Nomad

TRANSMITTAL LETTER
FOR
SERVICE BULLETIN NMD-55-21 Rev 1

UPPER FIN REAR SPAR PICK-UP PLATE (Mod N602)

UPPER FIN REAR SPAR PICK-UP PLATE (MOD N602)

Figure 2 View on LHS of Upper Fin - Post-Mod N602

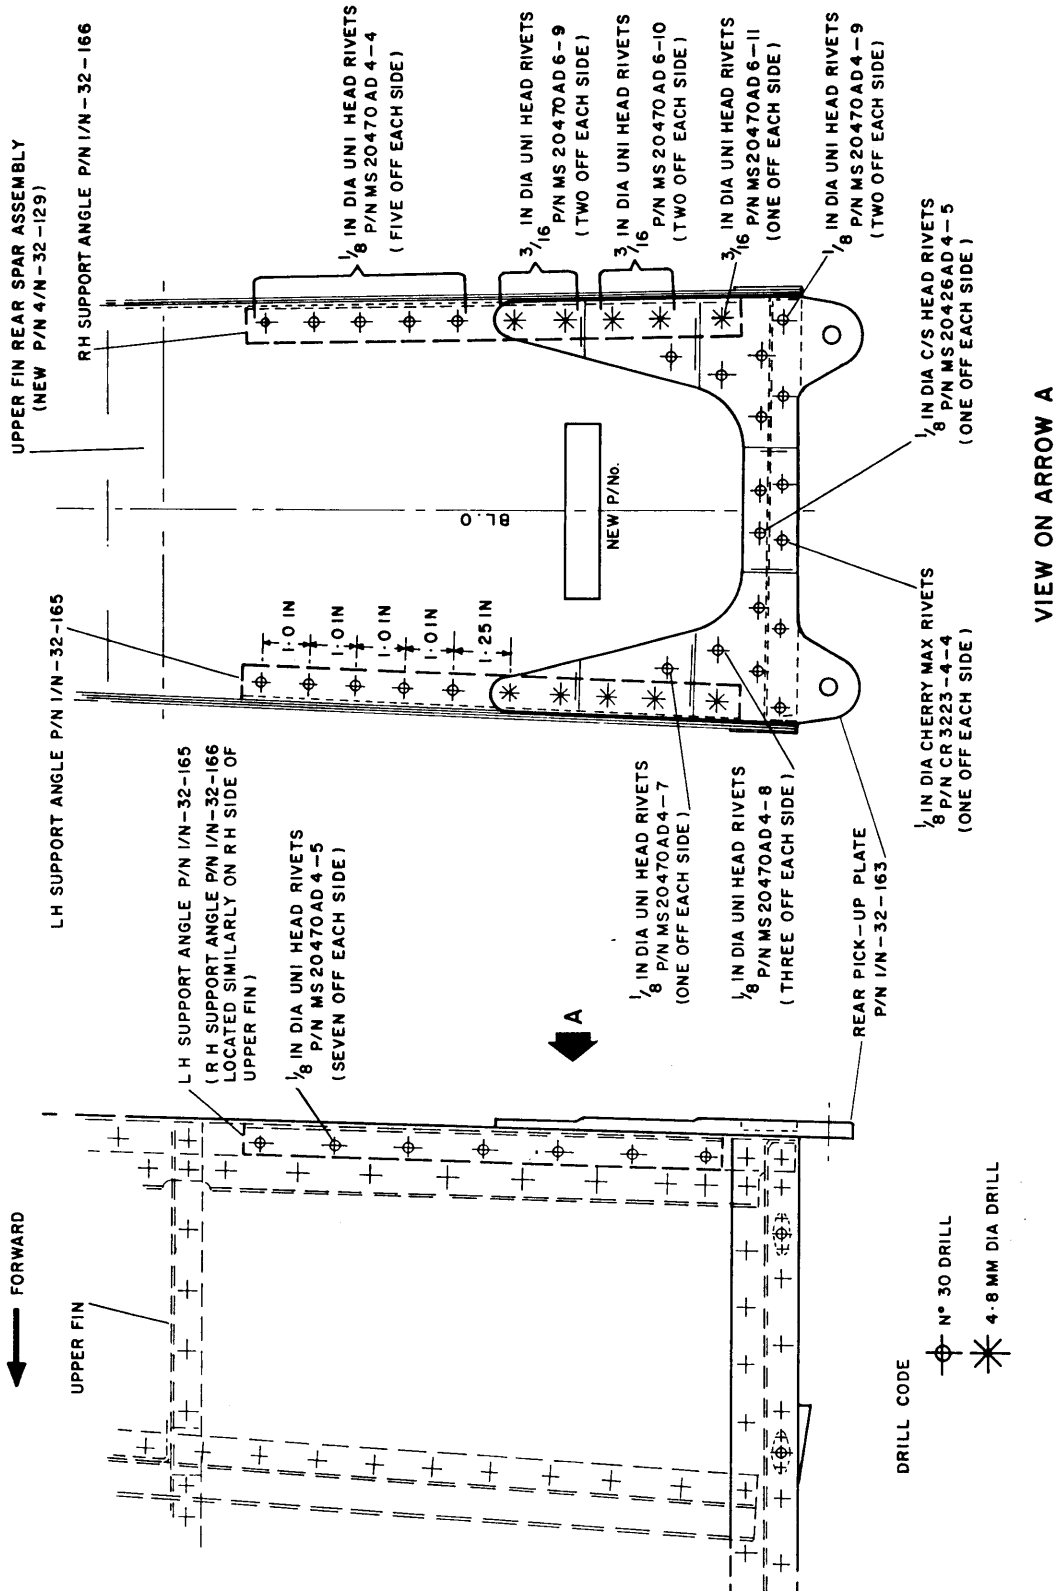
The existing rear pick-up plate is removed and replaced by a re-designed plate of increased thickness and two reinforcing support angles are added.

- J. Using service pins attach the new pick-up plate PN 1/N-32-163-950 to the fin utilising holes other than the 4.8 mm dia holes nominated, as shown in Figure 2. Drill the uppermost hole of the plate through the fin rear spar. This is necessary to establish the position of the new LH support angle PN 1/N-32-165-950.

- O. Using the pick-up plate as a drill guide drill five 4.8 mm dia holes in each of the LH and RH support angles. Remove the pick-up plate.
- P. Using a No 30 drill, drill the 10 new rivet holes through the rear spar assembly and support angles. (Ref Fig 2).

- S. Rivet the angles and pick-up plate to the upper fin using rivets detailed in Figure 2. Remove excess jointing compound.
- T. Re-identify the upper fin assembly PN 1/N-32-120 as PN 2/N-32-120 NMD-55-21 in the area shown in Figure 2.
